Product Change Notification / ASER-23WWAI681

CCB 4235 Final Notice: Qualification of MMT as a new final test site for selected Atmel AT27C/BV/LVxxxPU/JUxxx products

PCN # ASER-23WWAI681
CCB 4235_Pre and Post Change Summary

PLCC 32 CARRIER TAPE

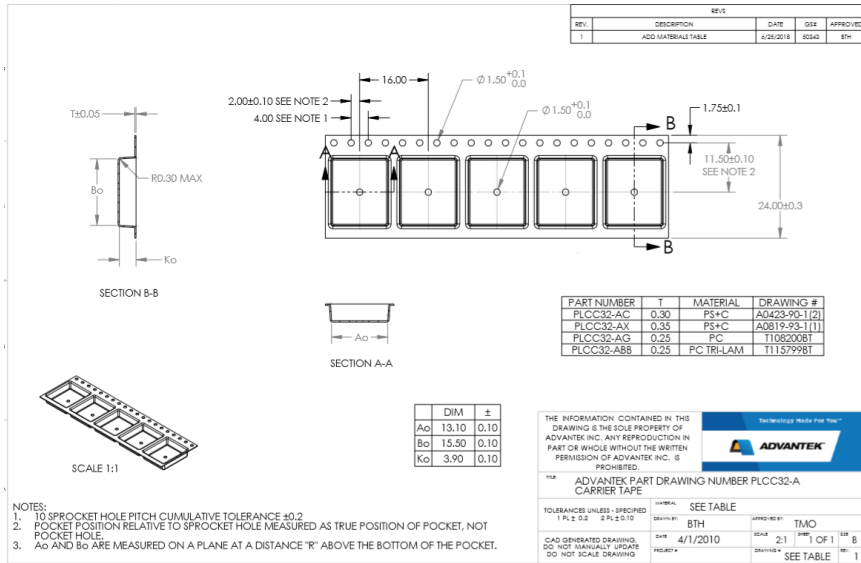
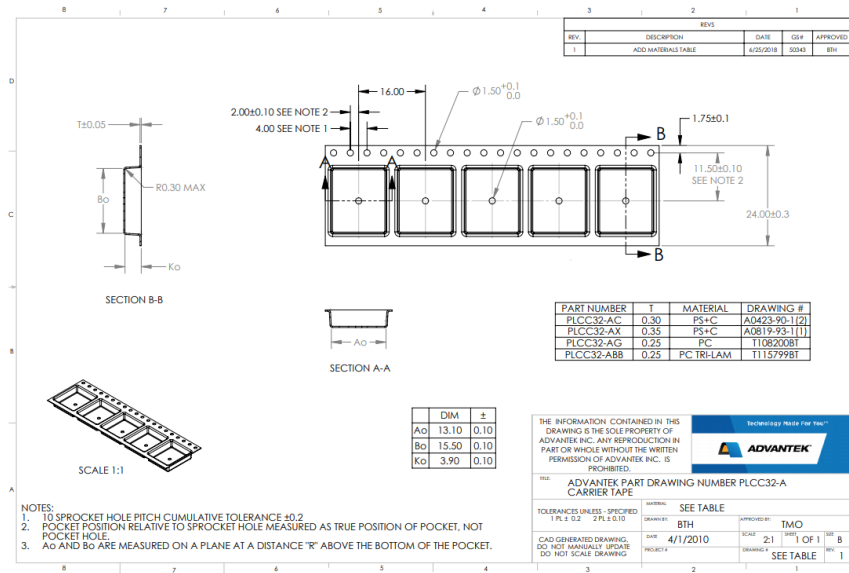
Supplier	Mfg. Part No.	W (mm.) ±0.3 or Specific	P (mm.) ±0.1 or Specific	A ₀ ±0.1 or Specific	B ₀ ±0.1 or Specific	K ₀ ±0.1 or Specific	Thickness
Advantek	PLCC32-AC170.P1	24	16	13.10/-0.1	15.50+/-0.1	3.90+/-0.10	-

Supplier	Mfg. Part No.	W (mm.) ±0.3 or Specific	P (mm.) ±0.1 or Specific	A ₀ ±0.1 or Specific	B ₀ ±0.1 or Specific	K ₀ ±0.1 or Specific	Thickness
Advantek	PLCC32-AC170.M1	24	16	13.10/-0.1	15.50+/-0.1	3.90+/-0.10	0.30 +/-0.05

PLCC 44 CARRIER TAPE

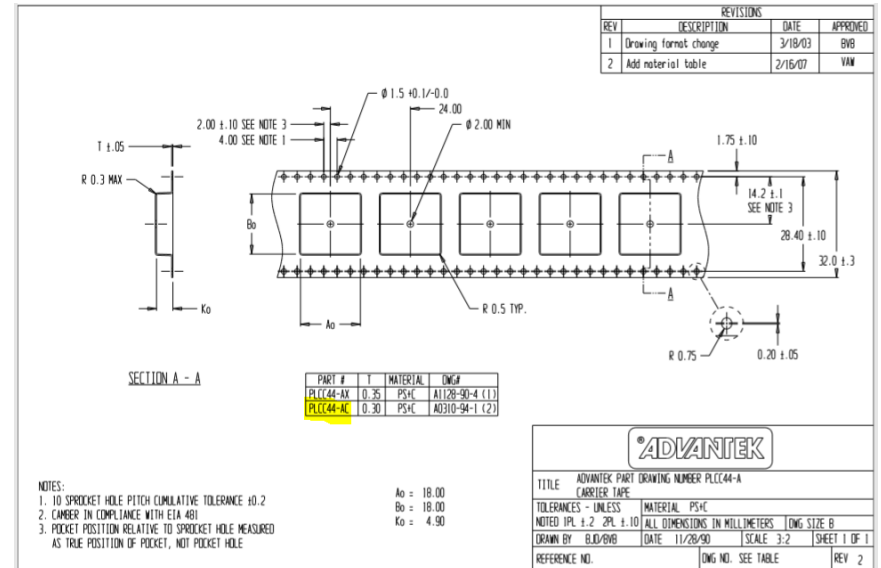
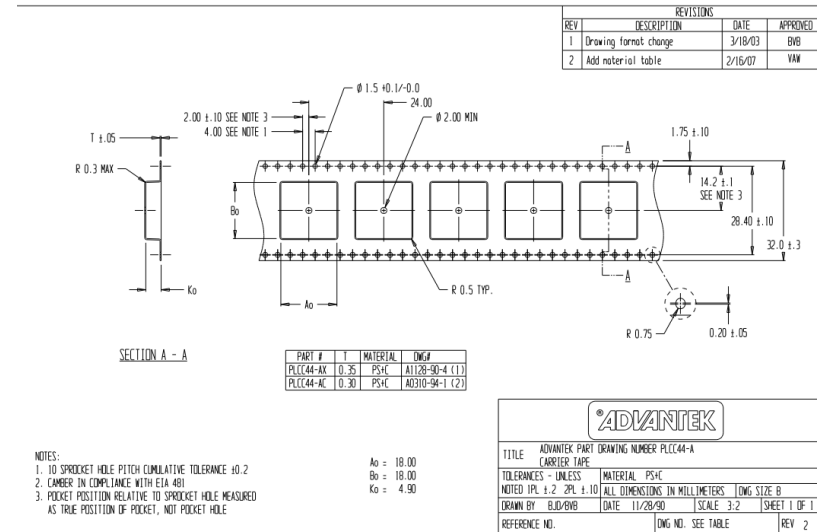
Supplier	Mfg. Part No.	W (mm.) ±0.3 or Specific	P (mm.) ±0.1 or Specific	A ₀ ±0.1 or Specific	B ₀ ±0.1 or Specific	K ₀ ±0.1 or Specific	Thickness
Advantek	PLCC44-AC88.0R5	32	24	18+/-0.1	18+/-0.1	4.9+/-0.1	-

Supplier	Mfg. Part No.	W (mm.) ±0.3 or Specific	P (mm.) ±0.1 or Specific	A ₀ ±0.1 or Specific	B ₀ ±0.1 or Specific	K ₀ ±0.1 or Specific	Thickness
Advantek	PLCC44-AC88.0R5	32	24	18+/-0.1	18+/-0.1	4.9+/-0.1	0.30 +/-0.05

PLCC 32 COVER TAPE (Width: 24mm)

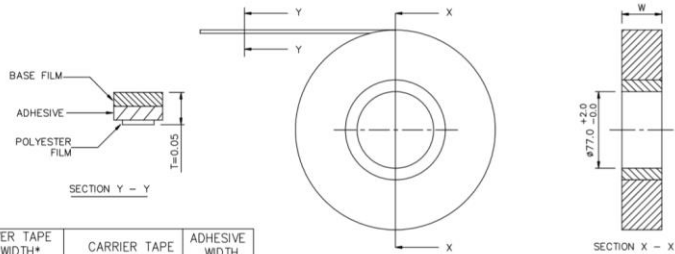
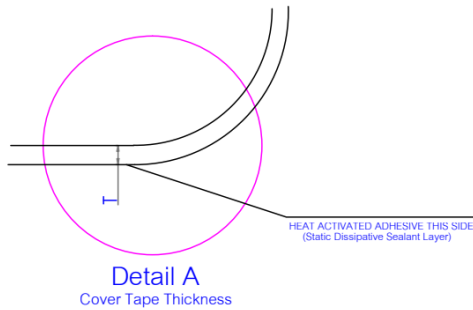
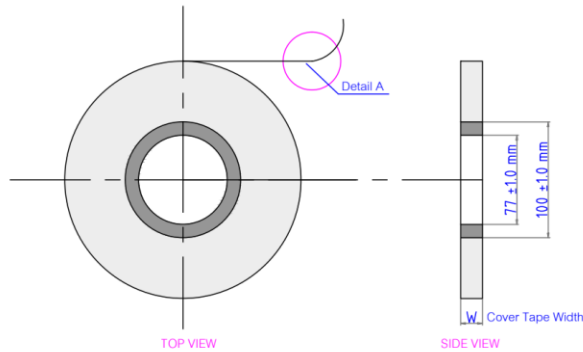
Carrier Width	Supplier	MCHP P/N	Supplier Part	Width "W" (mm)	Thickness (mm)	Sealing Mythology
24mm	CPak	211894	CP58 PSA	21.3 +/-0.1	0.050 ±0.010	Pressure Seal

Carrier Width	Supplier	MCHP P/N	Supplier Part	Width "W" (mm)	Thickness (mm)	Sealing Mythology
24mm	Sumitomo	22102002	CSL-Z7302	21.0 +/- 0.1	0.050 ±0.010	Heat Sealing

PLCC 44 COVER TAPE (Width: 32mm)

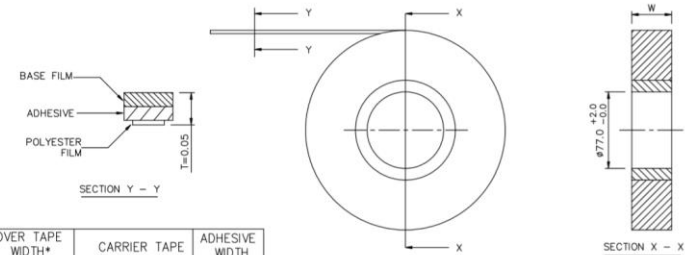
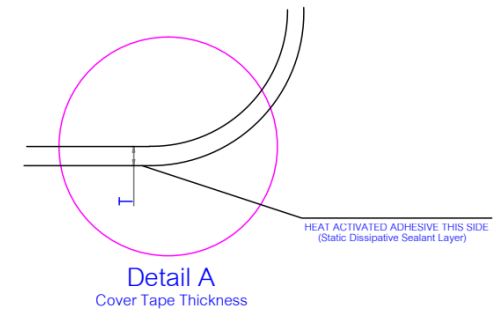
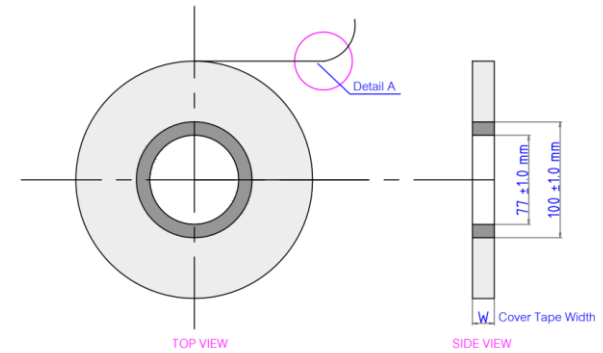
Carrier Width	Supplier	MCHP P/N	Supplier Part	Width "W" (mm)	Thickness (mm)	Sealing Mythology
32mm	CPak	211887	CP58 PSA	25.5 +/-0.1	0.050 ±0.010	Pressure Seal

Carrier Width	Supplier	MCHP P/N	Supplier Part	Width "W" (mm)	Thickness (mm)	Sealing Mythology
32mm	Sumitomo	22104401	CSL-Z7302	25.5 +/- 0.1	0.050 ±0.010	Heat Sealing

Plastic Reel (Width 24 mm)

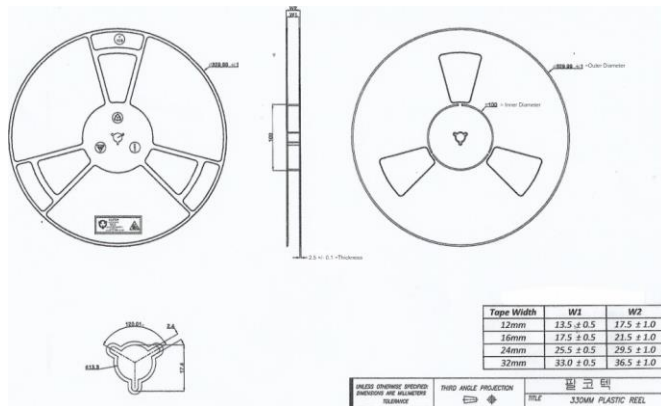
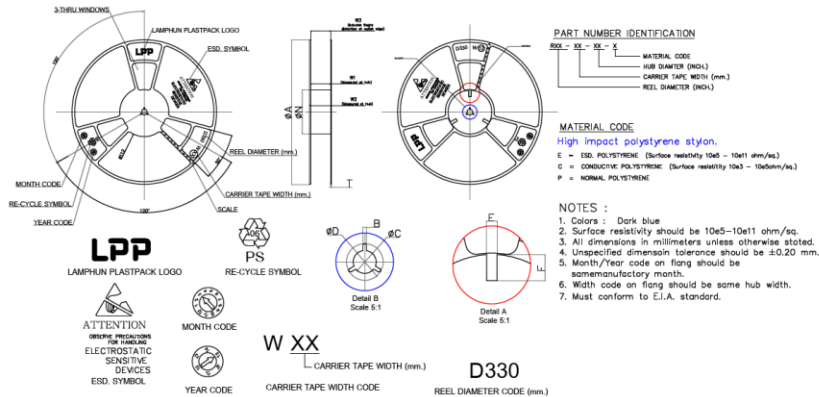
Width	MCHP P/N	Supplier Part	Hub	Color
24mm	211696	N/A	4inch (100mm)	White

Description	MPHIL	MMT
Color	White	Dark blue
Diameter	329.99 +/- 1.0	330 +/- 2.0
Hub	100	100 +/- 2.0
Width	25.5 +/- 0.5	24.4 +2.00/-0.00

Width	MCHP P/N	Supplier Part	Hub	Color
24mm	23000024	R13-24-04-E	4inch (100mm)	Dark Blue

Plastic Reel (Width 32 mm)

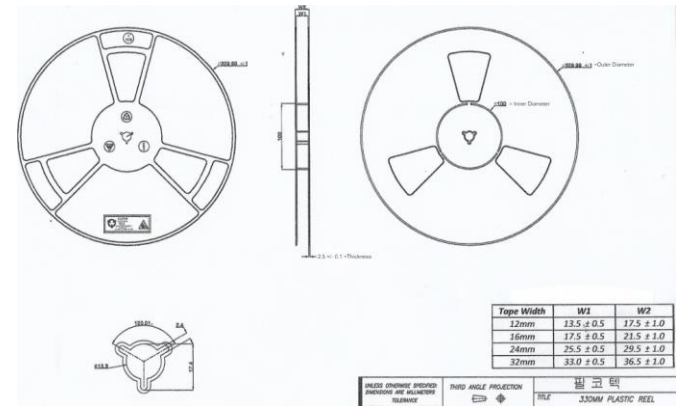
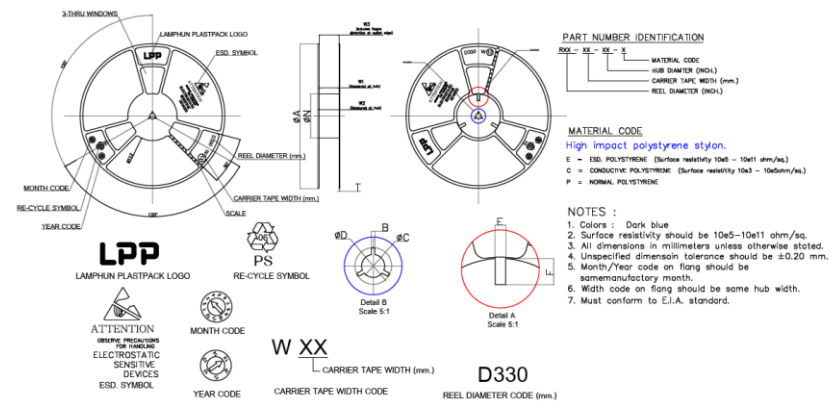
Width	MCHP P/N	Supplier Part	Hub	Color
32mm	211697	N/A	4inch (100mm)	White

Description	MPHIL	MMT
Color	White	Dark blue
Diameter	329.99 +/- 1.0	330 +/- 2.0
Hub	100	100 +/- 2.0
Width	33 +/- 0.5	32.4 +/- 2.0

Width	MCHP P/N	Supplier Part	Hub	Color
32mm	23000023	R13-32-04-E	4inch (100mm)	Dark Blue
